**802.1 maintenance item 0319:
Race condition in 802.1Q-2018
between List Config state machine
(clause 8.6.9.3) and Cycle Timer
state machine (clause 8.6.9.1)**

Alon Regev

AUG 11, 2021

Potential Solution #1 – part 1

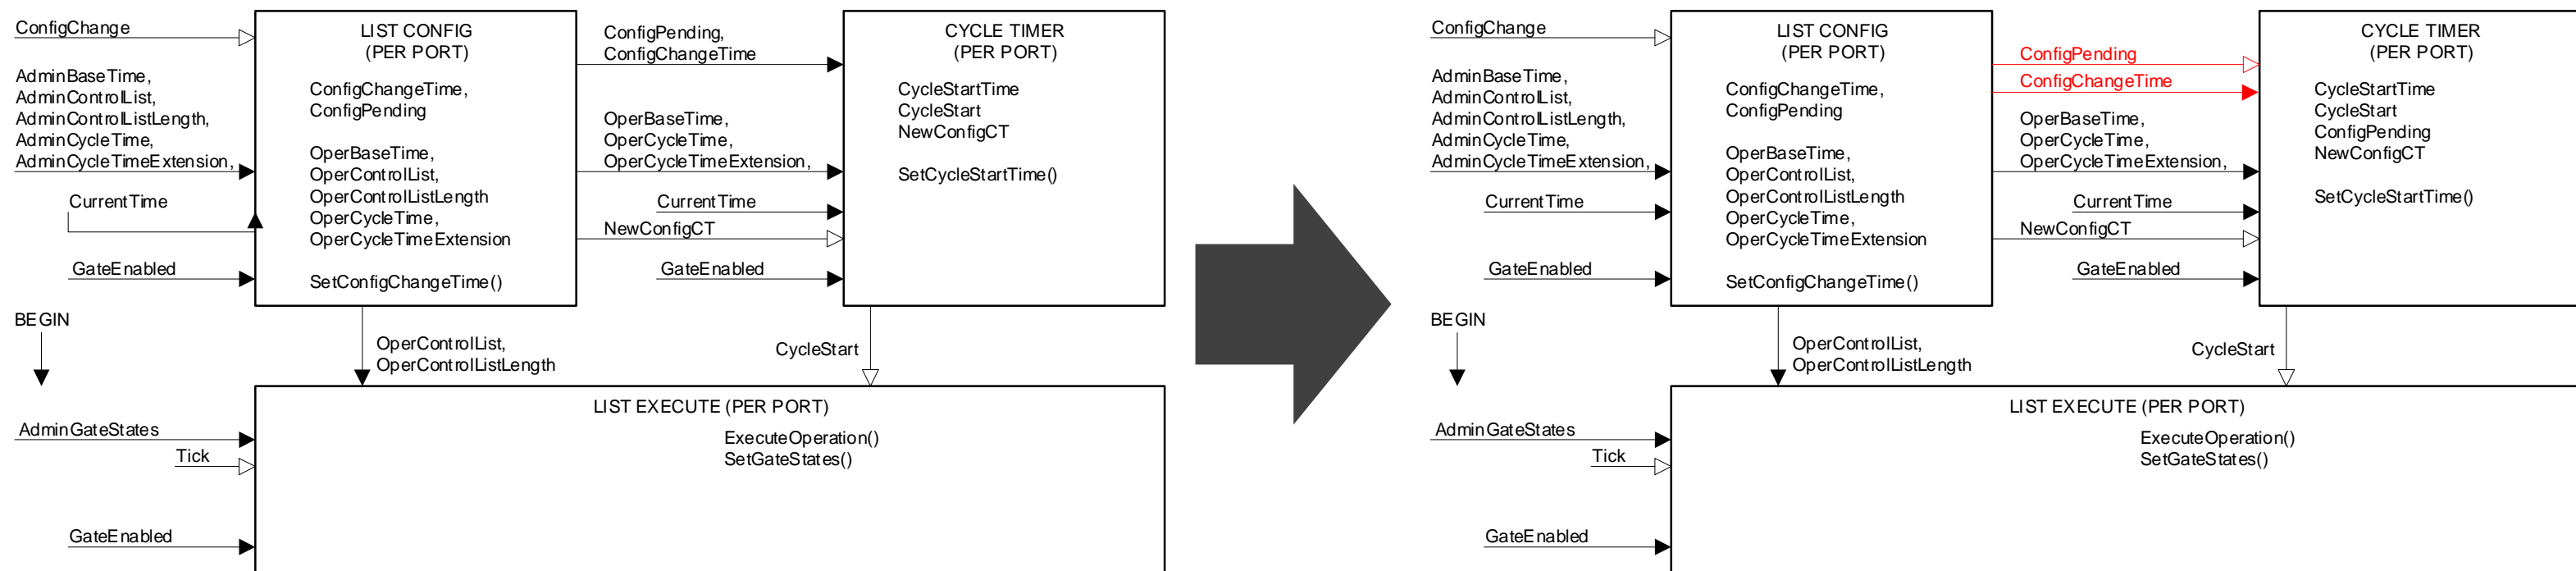
- In Clause 8.6.9.3 , Figure 8-18 (Scheduled traffic state machines—overview and relationships):
 - On the arrow with the text “ConfigPending, ConfigChangeTime”, change the text to “ConfigPending” and change the arrow shape to be one with the outline only (no fill).
 - Add an arrow underneath the ConfigPendingArrow starting at the “LIST CONFIG” box and ending at the “CYCLE TIMER” box with the text “ConfigChangeTime”, no arrow at the LIST CONFIG SIDE, and a filled in arrow at the CYCLE TIMER side.

Proposed solution #1 – part 2

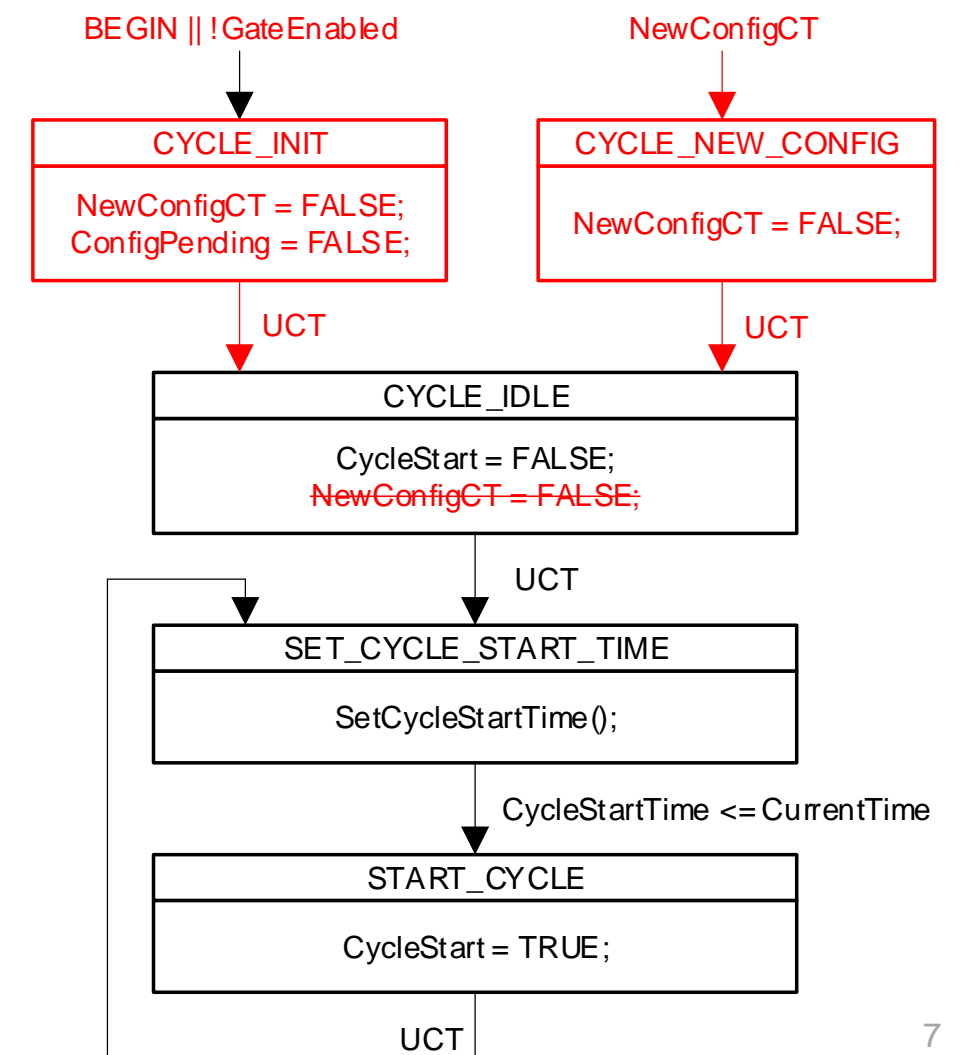
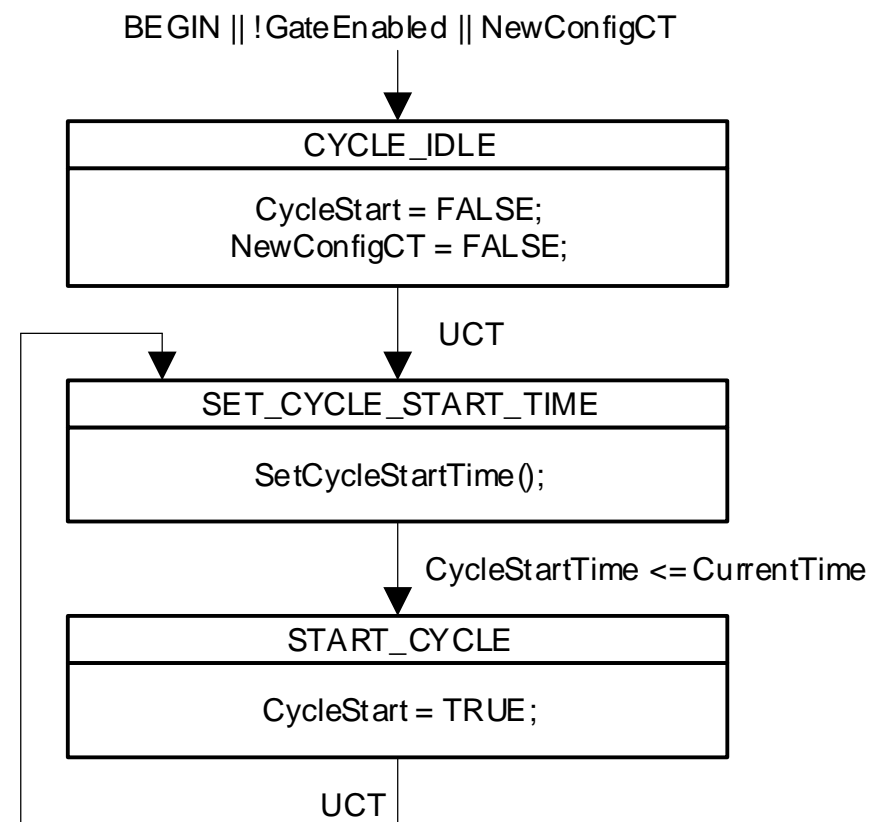
- In Clause 8.6.9.1 , Figure 8-19 (Cycle Timer State Machine):
 - Remove the global transition from “BEGIN || !GateEnabled || NewConfigCT” to CYCLE_IDLE

- Add a new state named “CYCLE_INIT”
 - This state will contain the lines “NewConfigCT = FALSE;” and “ConfigPending = FALSE;”
 - Add a global transition from “BEGIN || !GateEnabled” to the new CYCLE_INIT state

- Add a new state named “CYCLE_NEW_CONFIG”
 - This state will contain the line “NewConfigCT = FALSE;”
 - Add a global transition from “NewConfigCT” to the new CYCLE_INIT state

- Add an UCT transition from the CYCLE_INIT state to the CYCLE_IDLE state
 - Add an UCT transition from the CYCLE_NEW_CONFIG state to the CYCLE_IDLE state

- Add an UCT transition from the CYCLE_IDLE state to the SET_CYCLE_START_TIME state
 - Add an UCT transition from the SET_CYCLE_START_TIME state to the START_CYCLE state

- Add an UCT transition from the START_CYCLE state to the SET_CYCLE_START_TIME state
 - Remove the line “NewConfigCT = FALSE;” from the CYCLE_IDLE state

Potential Solution #1 – part 4

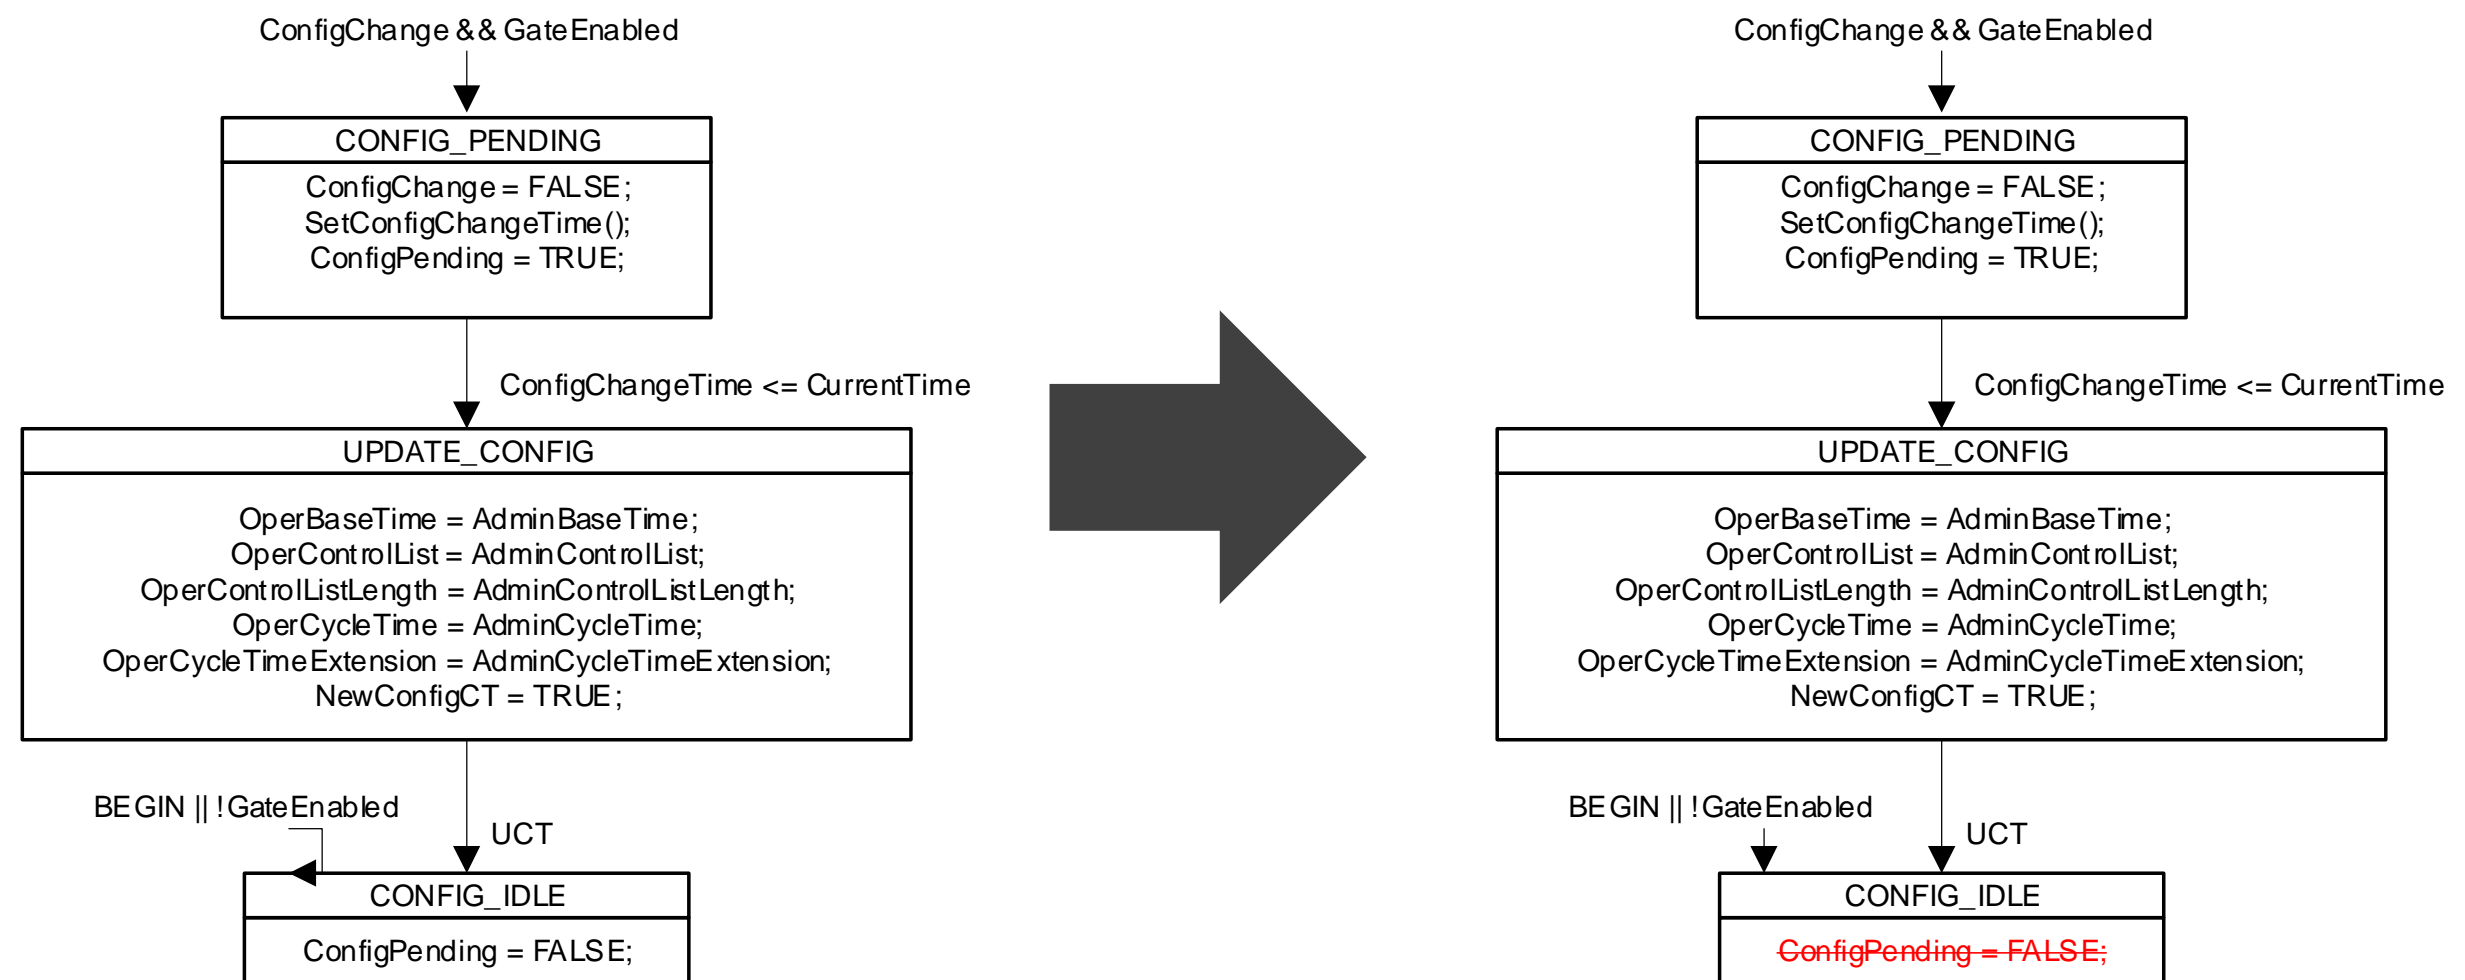
- In Clause 8.6.9.3 , Figure 8-21 (List Config State Machine):
 - In the CONFIG_IDLE block, remove the “ConfigPending = FALSE;” line

Proposed solution #2 – part 1

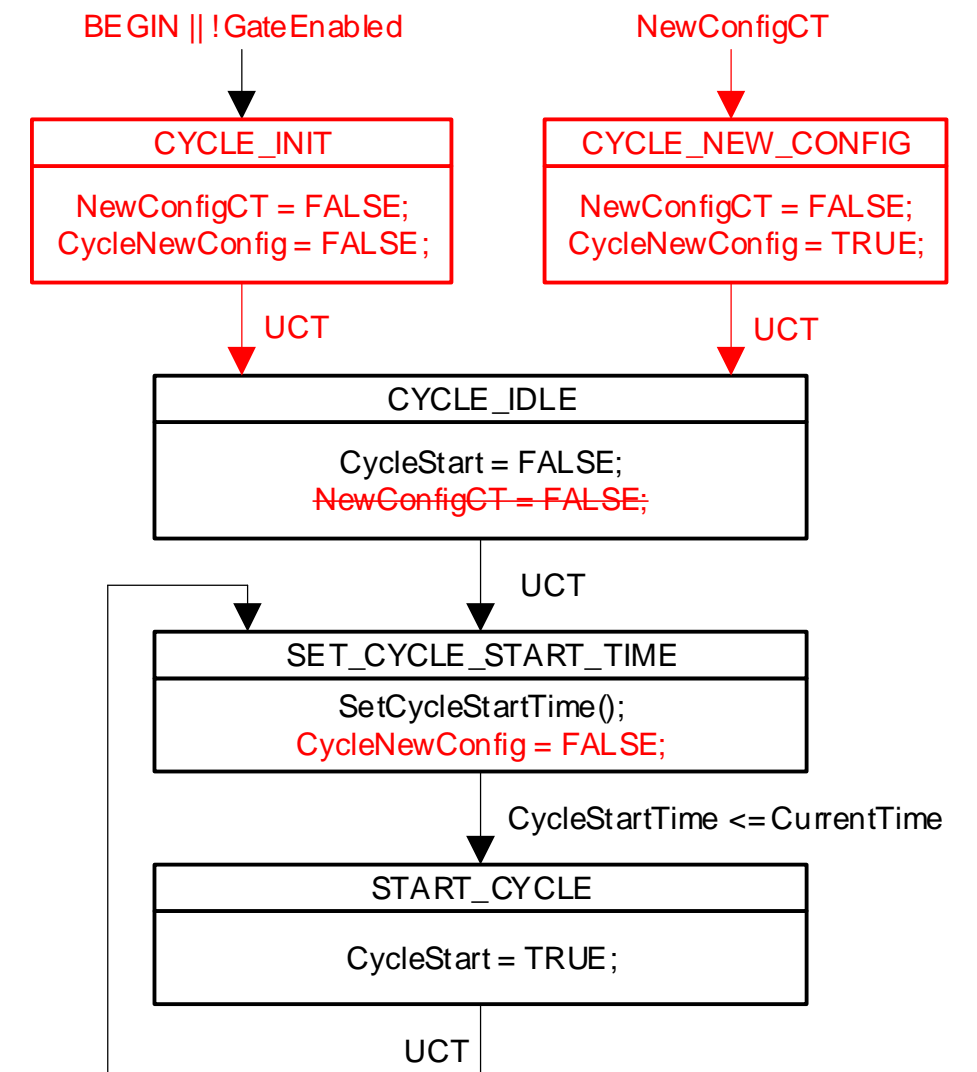
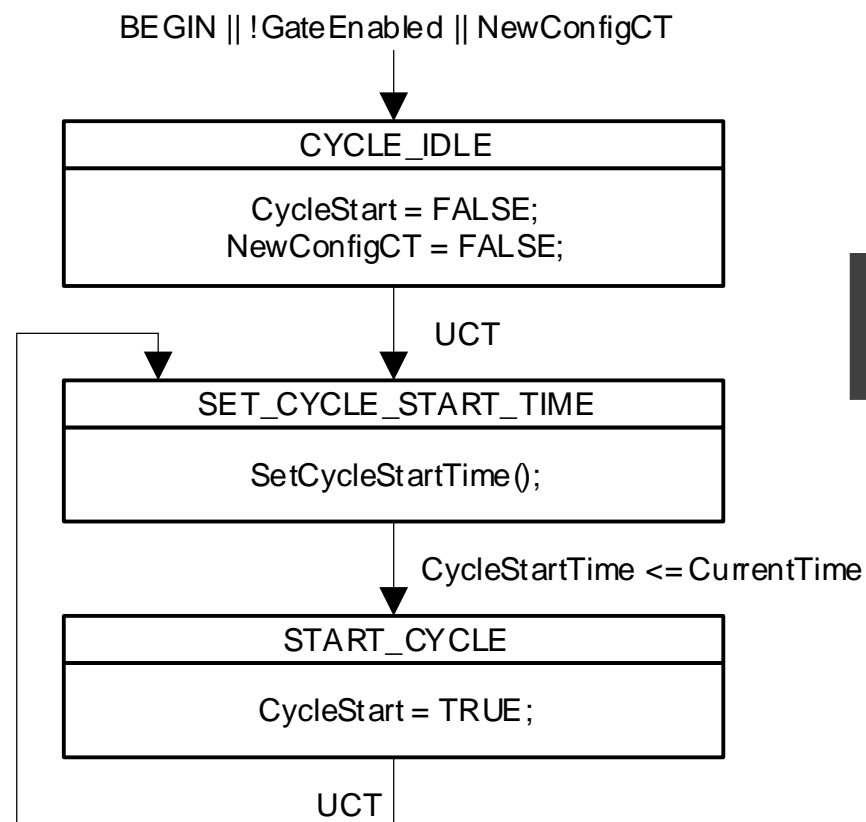
- In Clause 8.6.9.1 , Figure 8-19 (Cycle Timer State Machine):
 - Remove the global transition from “BEGIN || !GateEnabled || NewConfigCT” to CYCLE_IDLE

- Add a new state named “CYCLE_INIT”
 - This state will contain the “NewConfigCT = FALSE;” and “CycleNewConfig = FALSE;”
 - Add a global transition from “BEGIN || !GateEnabled” to the new CYCLE_INIT state

- Add a new state named “CYCLE_NEW_CONFIG”
 - This state will contain the “NewConfigCT = FALSE;” and “CycleNewConfig = TRUE;”
 - Add a global transition from “NewConfigCT” to the new CYCLE_NEW_CONFIG state

- Add an UCT transition from the CYCLE_INIT state to the CYCLE_IDLE state
 - Add an UCT transition from the CYCLE_NEW_CONFIG state to the CYCLE_IDLE state

- Remove the line “NewConfigCT = FALSE;” from the CYCLE_IDLE state
 - In the SET_CYCLE_START_TIME, after “SetCycleStartTime()” add a new line containing “CycleNewConfig = FALSE;”
